CITY PLANNING COMMISSION

- APPLICATION:**
- A. Negative Declaration
 - B. Special Permit for an existing 3,705+ sq. ft. church and a 1,440 sq. ft. classroom addition
 - C. Variance to waive the required 6 foot masonry wall along the east and west property lines on 0.92+ developed acres in the Standard Single Family-Executive Airport Overlay 4 [R-1(EA-4)] zone

LOCATION: 2900 29th Avenue

PROPOSAL: The applicant is requesting the necessary entitlements to allow an existing church and a classroom addition.

EXHIBIT A

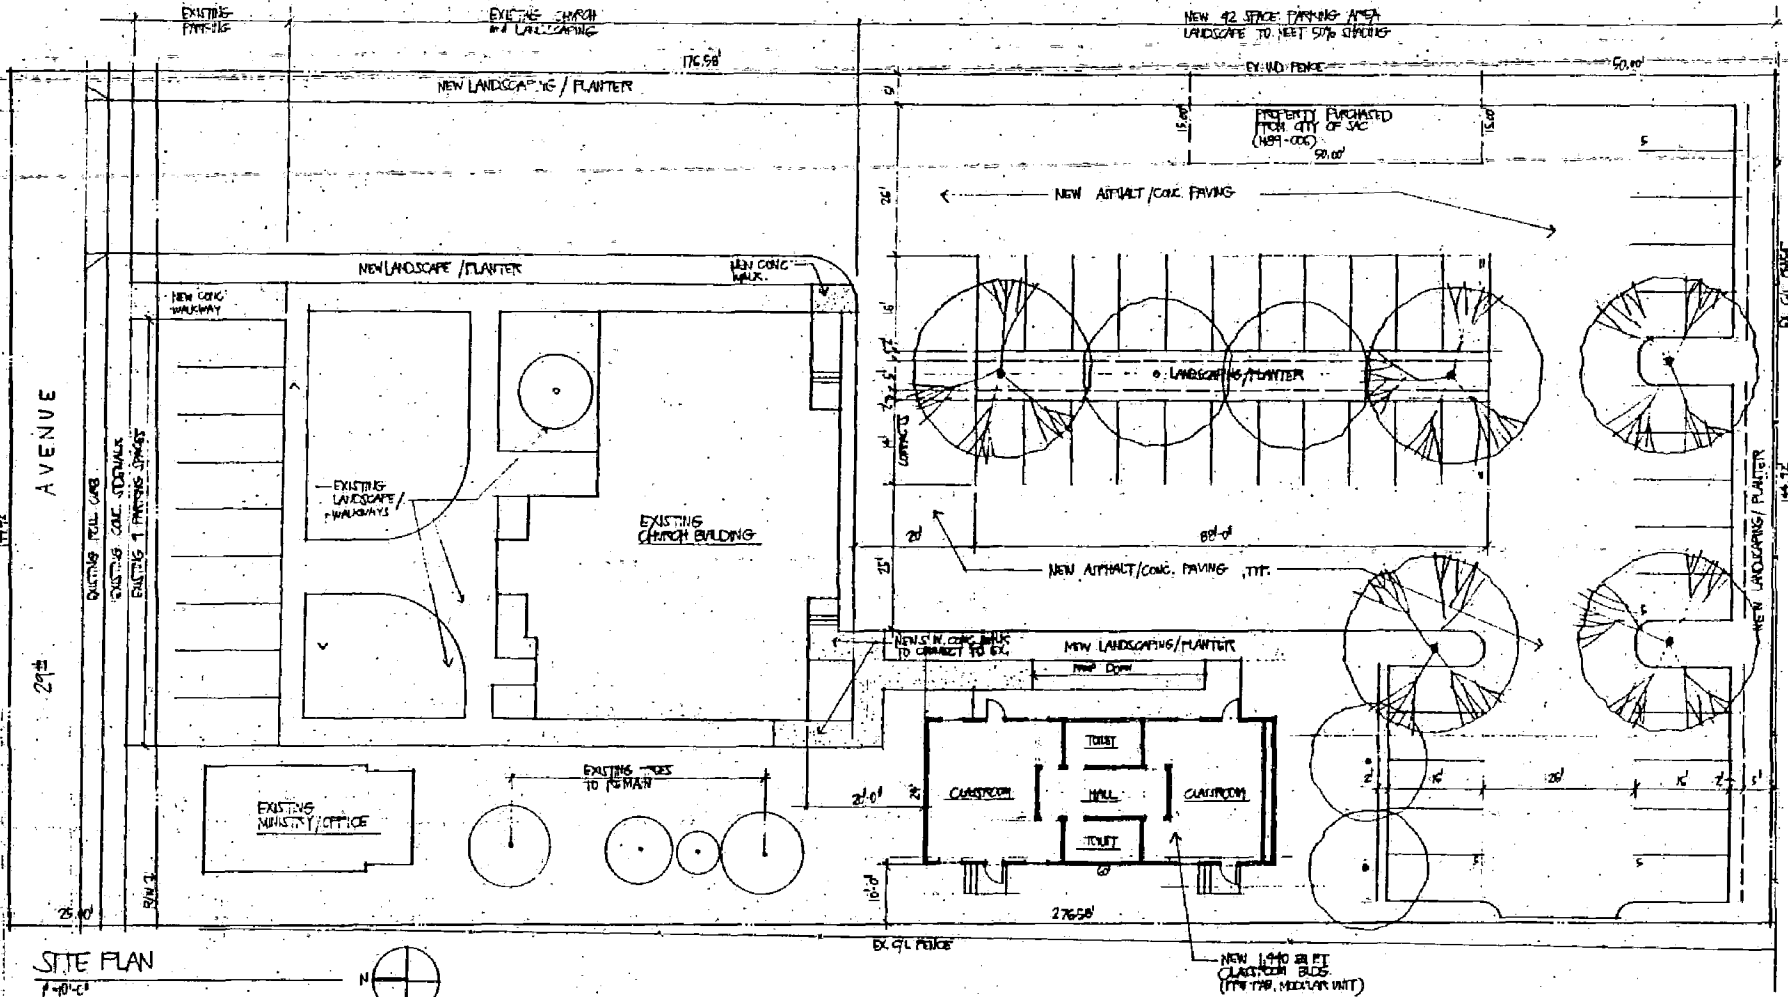
The applicant is proposing to add a 1,440 square foot education building to an existing church. The applicant also requests waiver of the required 6 foot masonry wall required between residential and non-residential uses. The rear of the lot will be improved with landscaping and parking as part of the addition. There are currently nine parking spaces in the front of the church and the proposal includes an additional 46 spaces in the rear.

The building consists of a 24' x 60' modular unit that includes two classrooms and two rest rooms. The building has a metal roof and plywood siding which will be painted to match the existing church.

EXHIBIT B

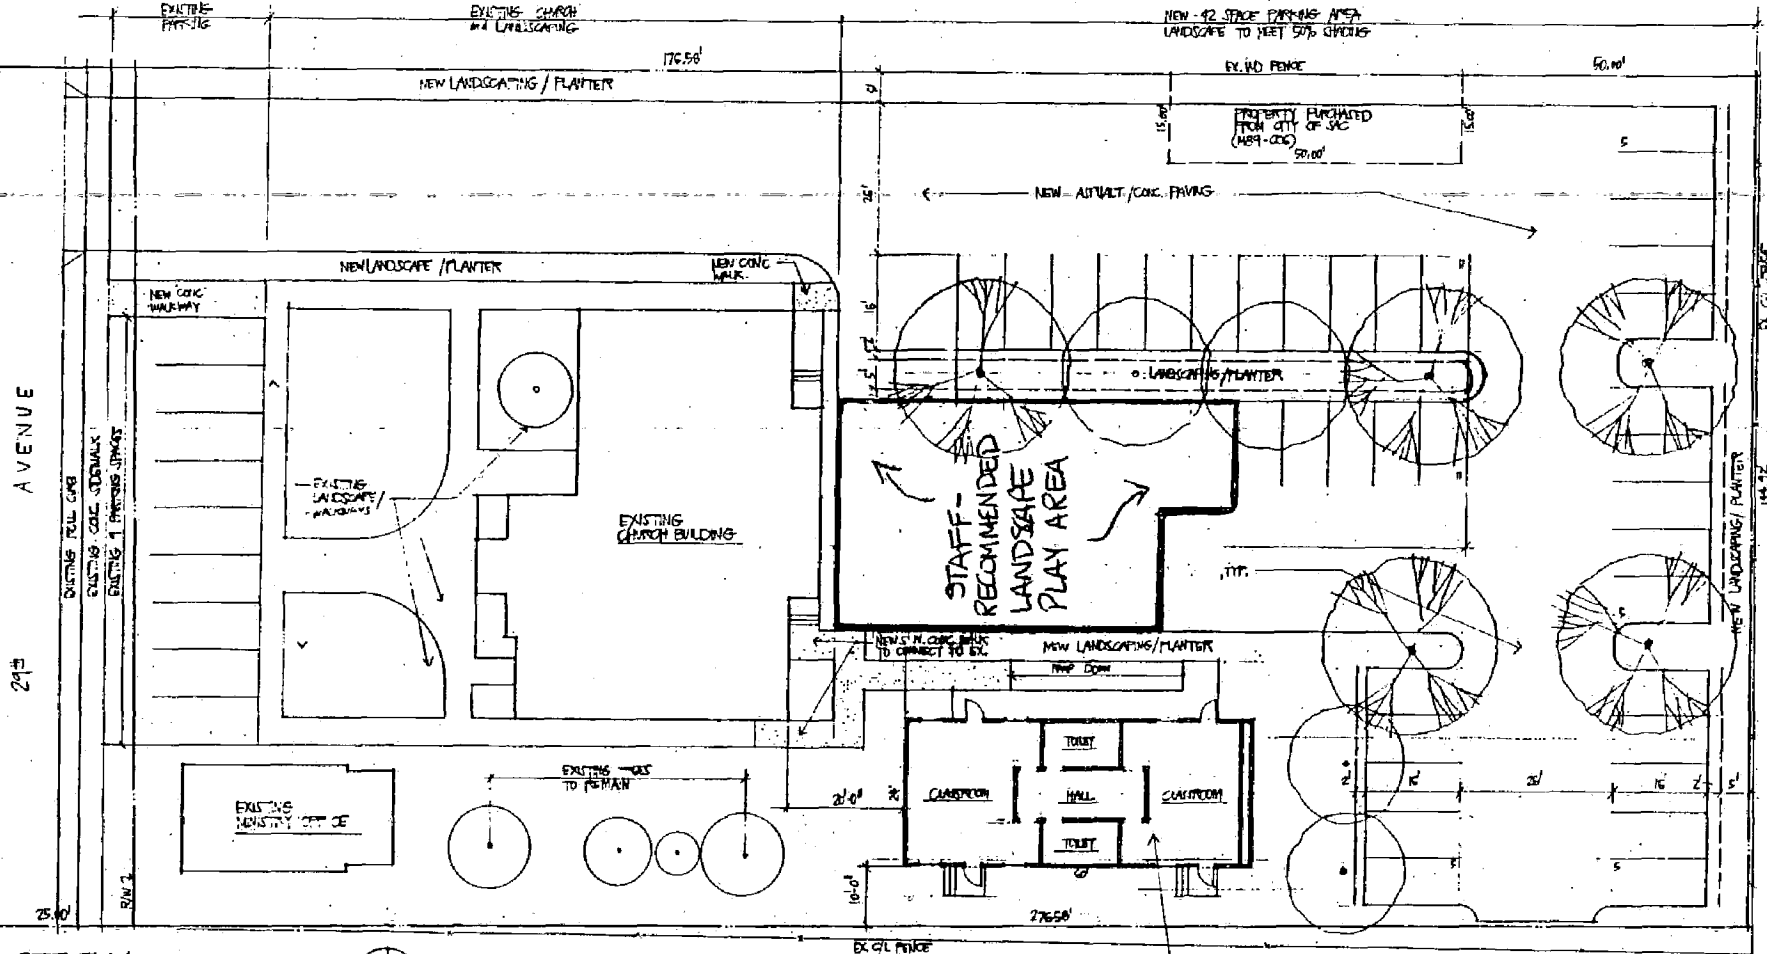
The church has a capacity of approximately 100 people. At the required ratio of one parking space for every six seats, 17 parking spaces are required. The proposal includes 51 parking spaces, 9 in the front and 42 in the rear. Staff recommends, due to the over abundance of parking, that the parking layout be altered in order to allow more landscaped open area around the classroom addition (see Exhibit B). Staff also suggests the nine parking spaces in front, which back out onto the street, be removed and replaced with landscaping for safety reasons, if feasible.

The applicant shall meet the 50 percent shading requirements of the Zoning Ordinance and increase the landscaped area as shown in Exhibit B.

1. Driveway is to be 10 feet from the property line.
2. Existing stalls on 29th Street do not comply with City Standards.
3. Round out ends of landscape planter in center of parking area.

1. The addition shall be compatible with the existing church.
2. The parking layout shall be altered as per Exhibit B.
3. The parking area shall be paved to City standards.
4. The applicant shall meet the 50 percent shade requirements of the Zoning Ordinance.
5. Additional landscaping shall be provided for the classroom addition, as per Exhibit B.
